DOCUMENT CHANGE NOTICE (DCN)

DOCUMENT No. (DOC-REV-GP. ID)	TITLE	NEW REV.
D980289-A	Cavity Beam Dump Glass Mounting Plate 1	B
D980292-A	Cavity Beam Dump Glass Mounting Plate 2	B
D980348-A	Cavity Beam Dump Side Plate	B
D980378-A	Cavity Beam Dump Stiffener Block	B

Cavity Beam Dump
Glass Mounting Plate 1

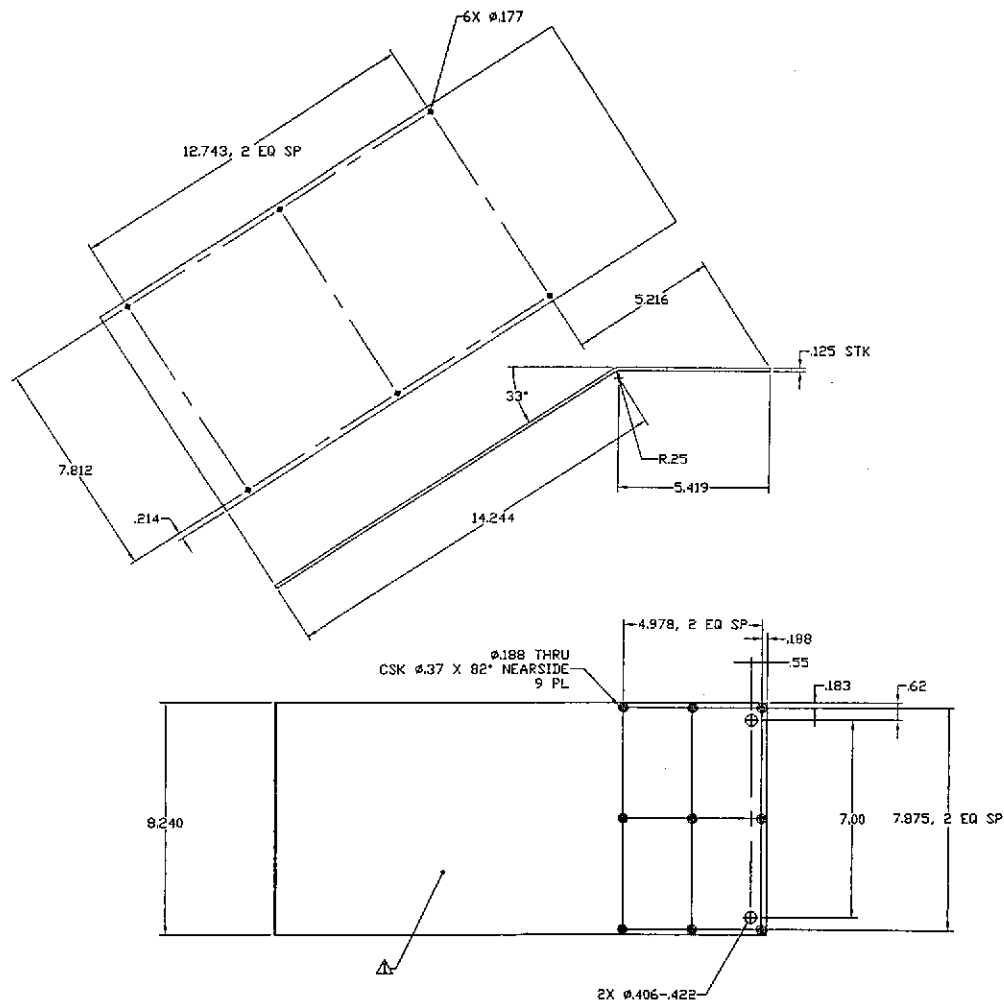
D980289: Revised callout for 9 countersunk screw holes, specifying countersink diameter.

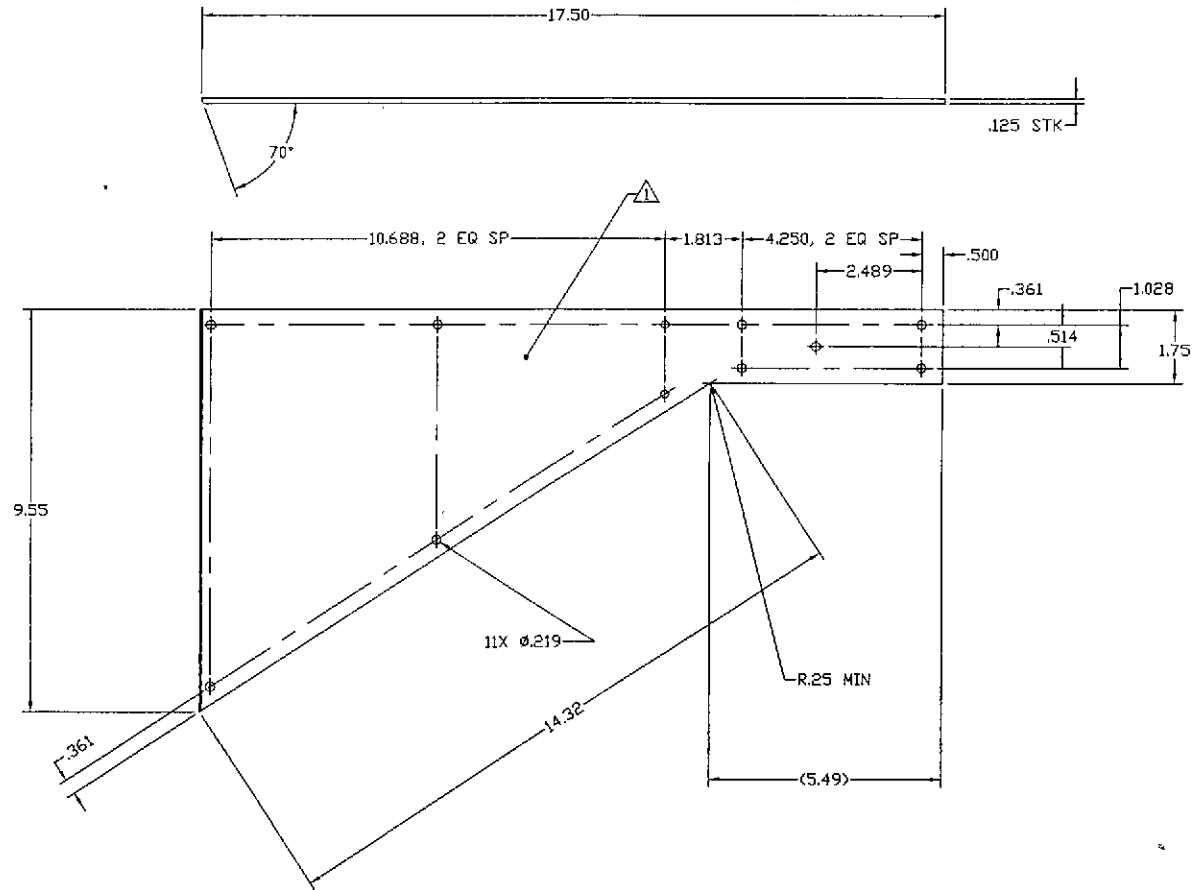
D980292: Revised callout for 9 countersunk screw holes, specifying countersink diameter. Added clearance holes for 3/8" mounting bolts (Identical to holes on D980289-A). Also made dimensional adjustments for proper fit.

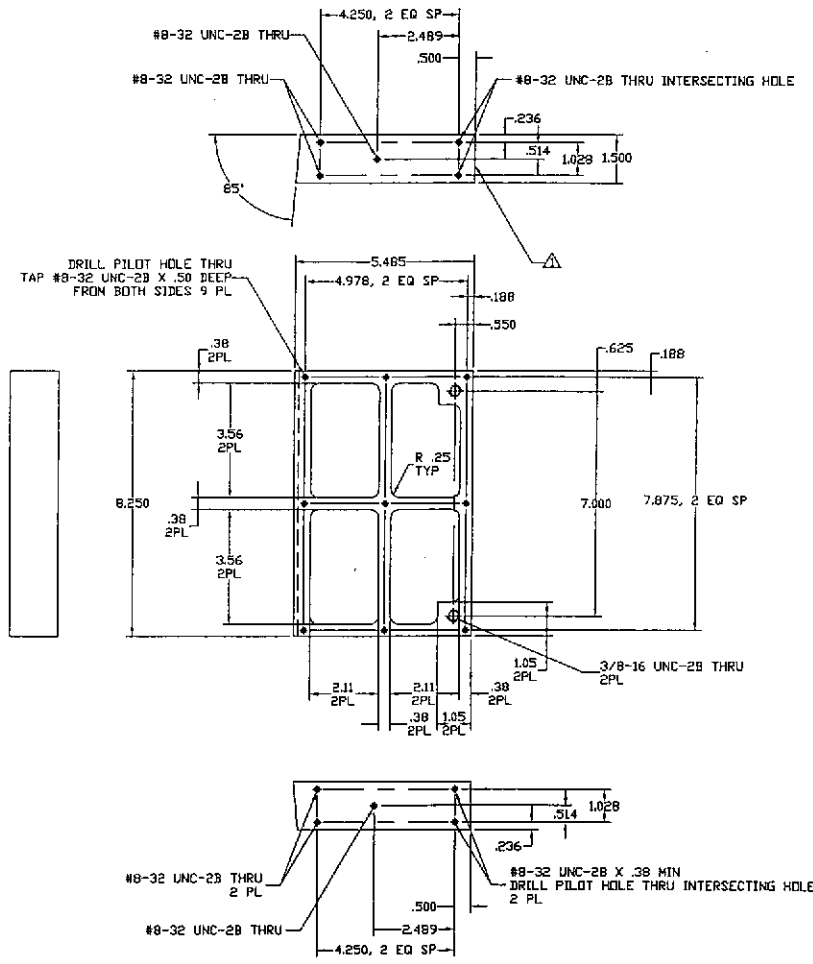
D980348: Changed all 11 clearance hole diameters from .177 to .219 to achieve fit on assembly.
